**OFFICE OF WATER SCIENCE ADVICE
FAIRVIEW WATER RELEASE SCHEME, 50 KILOMETERS (KM) EAST OF INJUNE,
QUEENSLAND**

Requesting section	Queensland North Assessments	Requesting officer	s. 22(1)(a)(ii)
Date of request	12/05/2021		
EPBC reference	EPBC 2021/8914	OWS reference	OWS 2021-037
Project assessment stage	Referral		
OWS contact officer	s. 22(1)(a)(ii) , s. 22(1)(a)(ii) , s. 22(1)(a)(ii)		
Cleared by	s. 22(1)(a)(ii) Director / Senior Principal Research Scientist Technical Analysis Team	Date	26 May 2021

This document, prepared at the request of the Environment Assessments Division, outlines the Office of Water Science's (OWS) technical advice on the Fairview Water Release Scheme QLD, in relation to the proposed action of controlled releases of desalinated and event-based untreated coal seam water associated with the Gladstone Liquefied Natural Gas Project Gas Field Development (GLNG GFD) into the Dawson River via a floodplain oxbow lake (the lake) and ephemeral watercourse.

Attachment A –Monitoring Locations Water Storage Dams

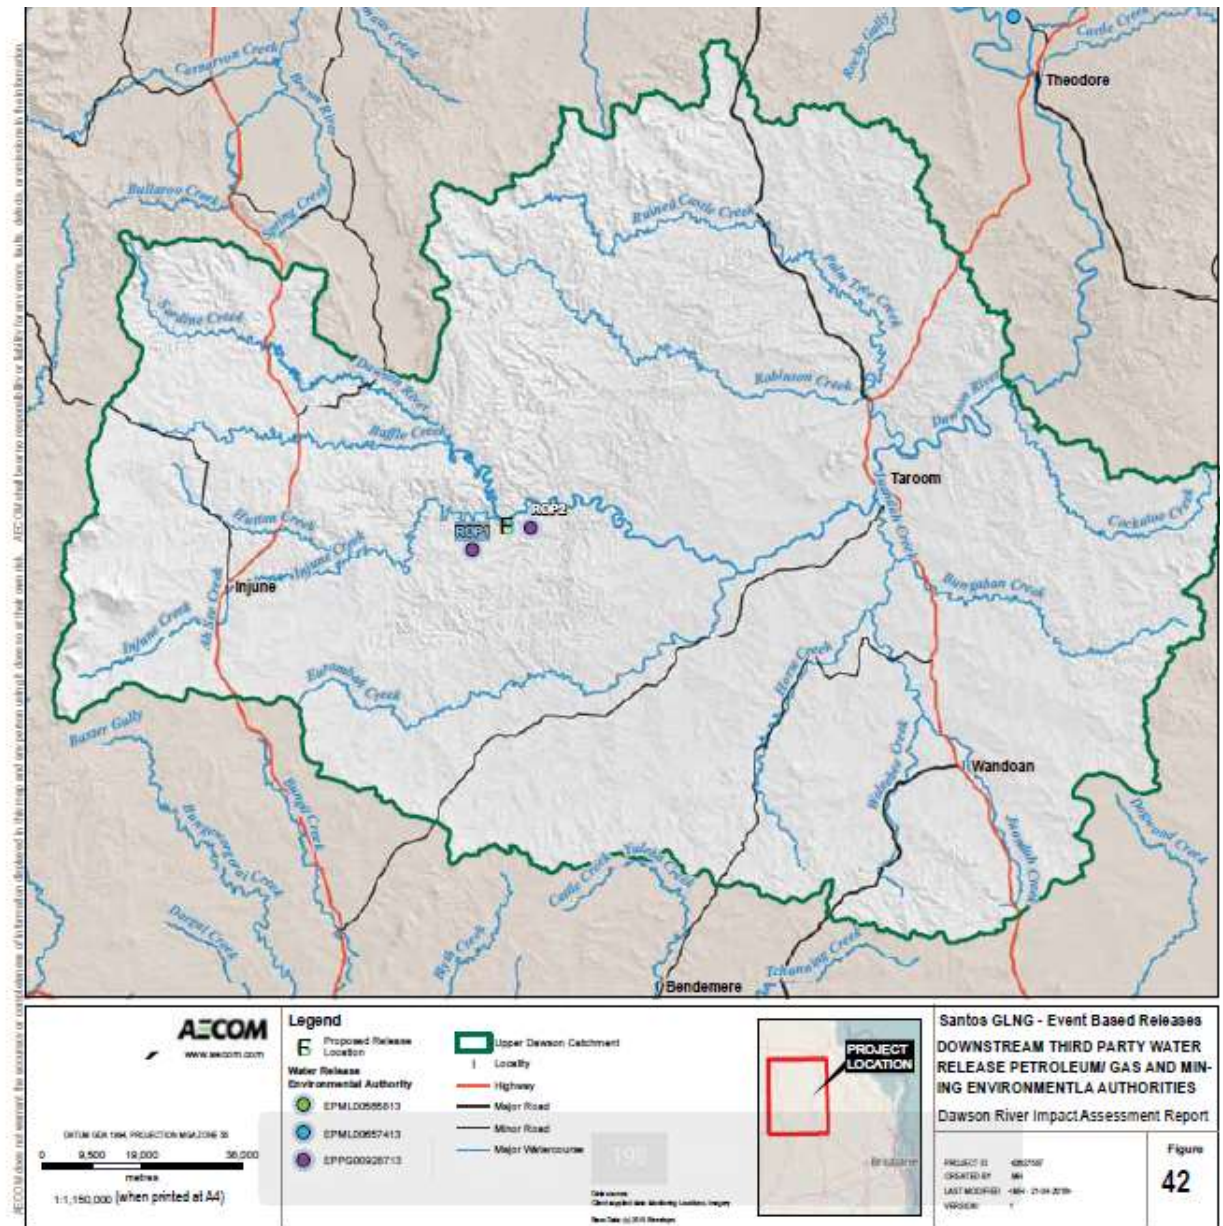
- c. The proponent's REMP monitoring design for the Dawson River Watercourse Releases Desalinated Releases Program (Table 6.3, FRC Environmental, 2021, p 47) has twice-yearly monitoring (notionally pre-wet season and post wet season) for physico-chemical parameters (nutrients, metals, major ions, and metalloids) of and

- weekly monitoring for total and dissolved boron for the ROP1 monitoring site (Attachment A).
- i. OWS considers weekly monitoring of boron to provide adequate temporal coverage to identify potential contamination issues which may occur. If monitoring sites S3a, S1a, S4, DRR1, DRMP1 and WLMP 1 – 5 (Attachment B and Map 6.1. FRC Environmental, 2021, p 44). were monitored more frequently (e.g. weekly) for all physico-chemical parameters than what is currently proposed (Table 6.3, FRC Environmental, 2021, p 47), potential contamination events would be identified earlier.
